House Type 3.2.1 - Plot 5

RIGHT SIDE ELEVATION

Project: Eaglebush, Meadow Rd, Neath	Drawn: CJW
Title: Bungalow Type 3.2.1	Checked: JD
2 BEDROOM 3.2.1-PLOTS 4 & 5	Scale: 1:50 @ A3
Right Side Elevation	Date: Jan 2022
Ref: 2430-02-(20)13 Rev: C	Status: Construction.

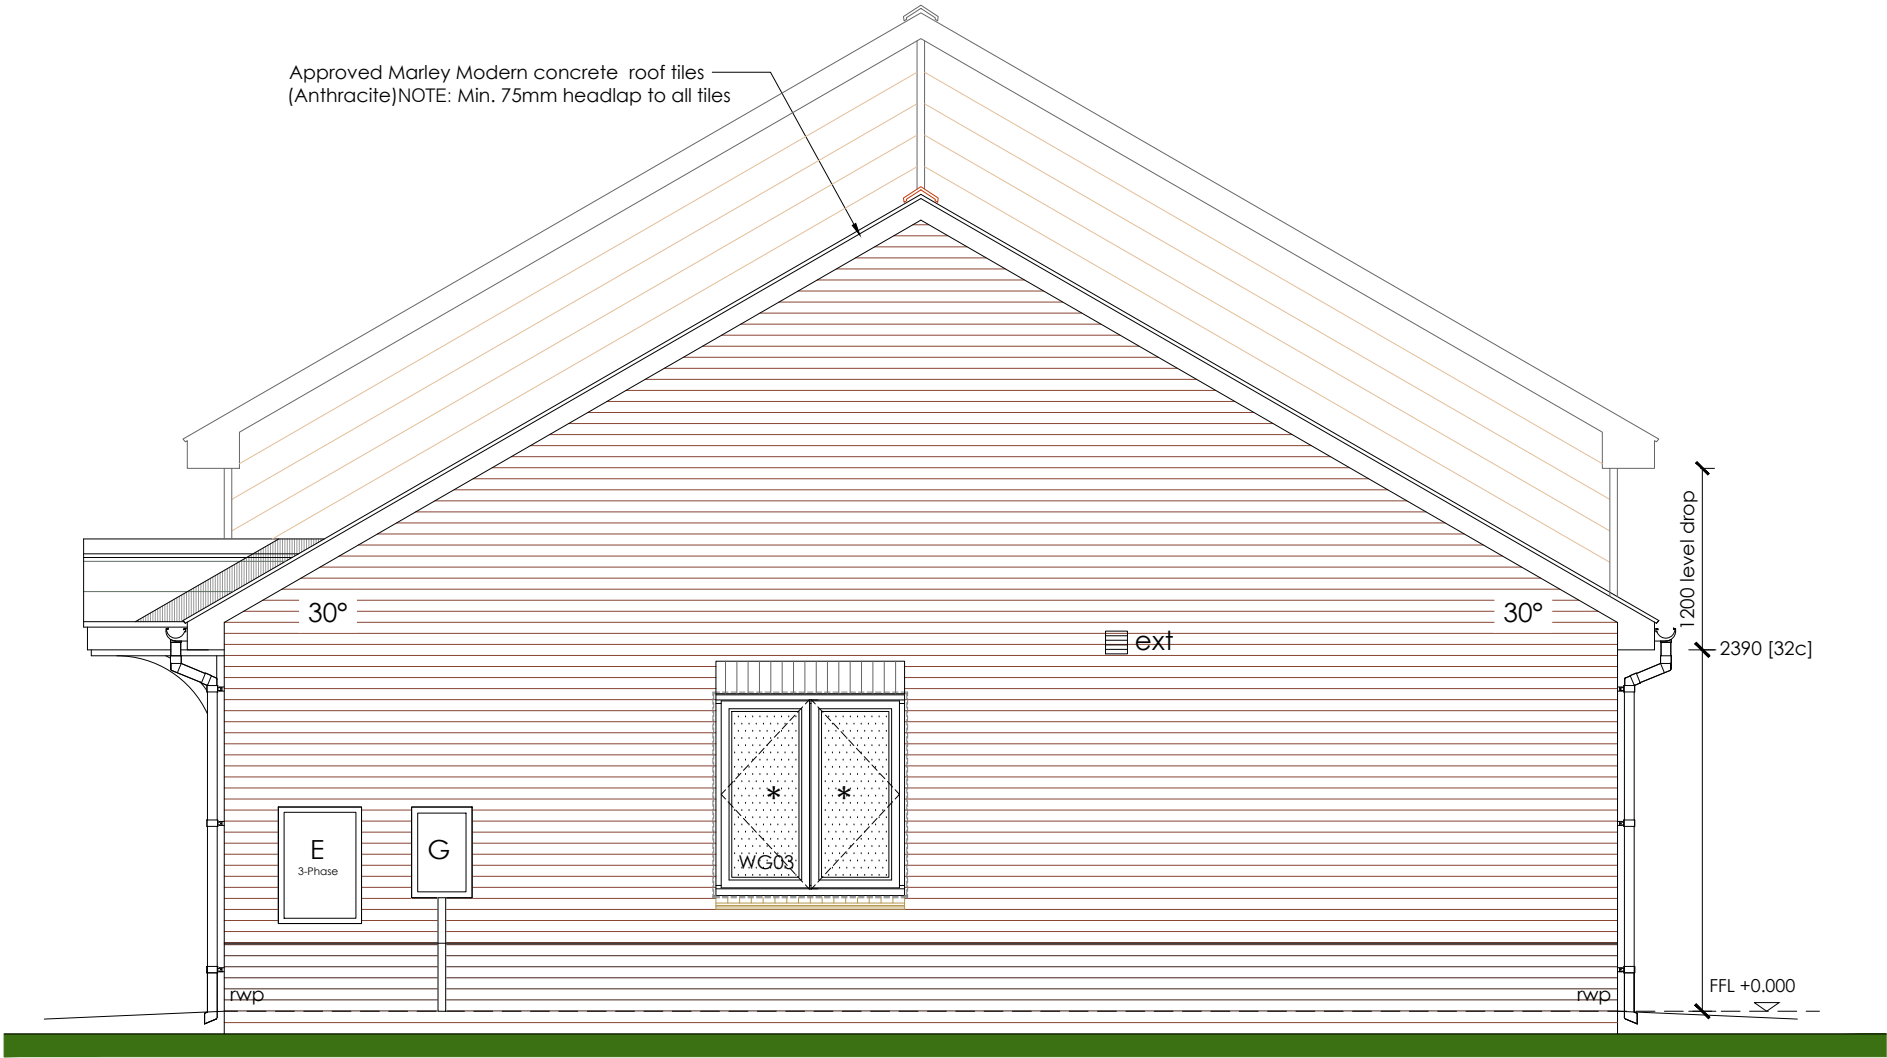
Hardie Plank Cedral cladding to stepped gable - on-site image

C	Cedral cladding to stepped gable added to side elevation	07.05.24	JWb
B	Plots 4&5 FFL dropped by 150mm to 1200mm between properties	20.07.22	JWb
A	Updated following Contactor comments on prelim issue	15.03.22	JWb
